**WESTSIDE COMMUNITY CENTER
2932 S IH Frontage Road
New Braunfels, TX 78130**

ADA SELF-EVALUATION FACILITY SURVEY

New Braunfels Westside Community Center

Jun 29, 2021

#48 Priority 3: Water Closets

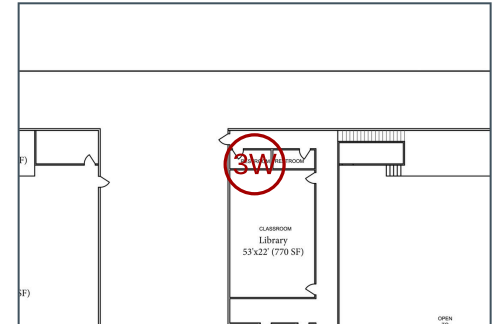
The paper towel dispenser overlaps the 60" wide clear floor space at the water closet.

Recommendation: Relocate paper towel dispenser outside of required water closet clearance.

#51 Priority 3: Water Closets

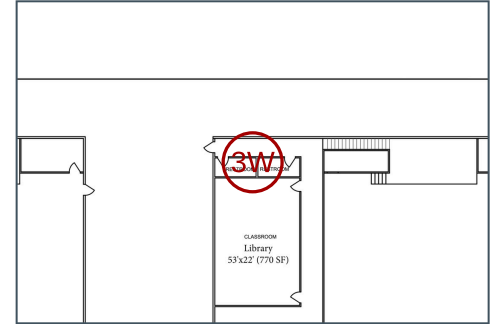
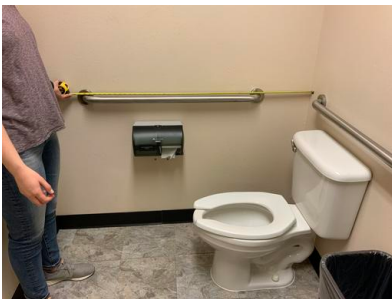
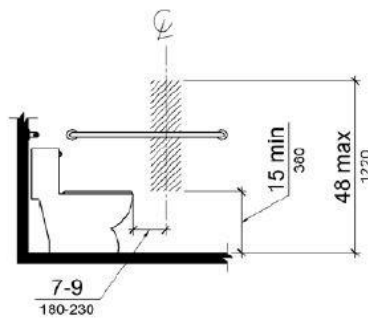
The toilet paper dispenser is centered approximately 5" from the front of the water closet.

Reposition dispenser with centerline 7" to 9" in front of water closet.

#2 Priority 4: Vending Machines

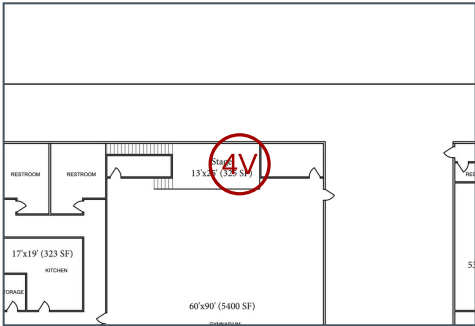
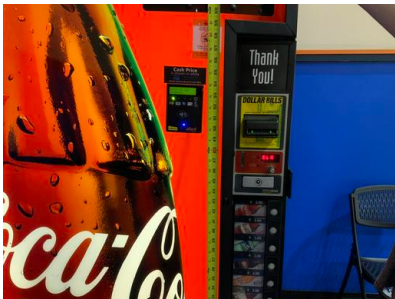
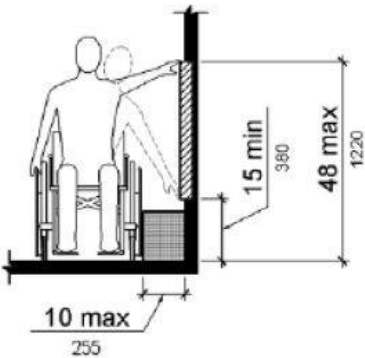
Description
The card slide at the vending machine is 54" high.

Recommendation: Replace vending machine.
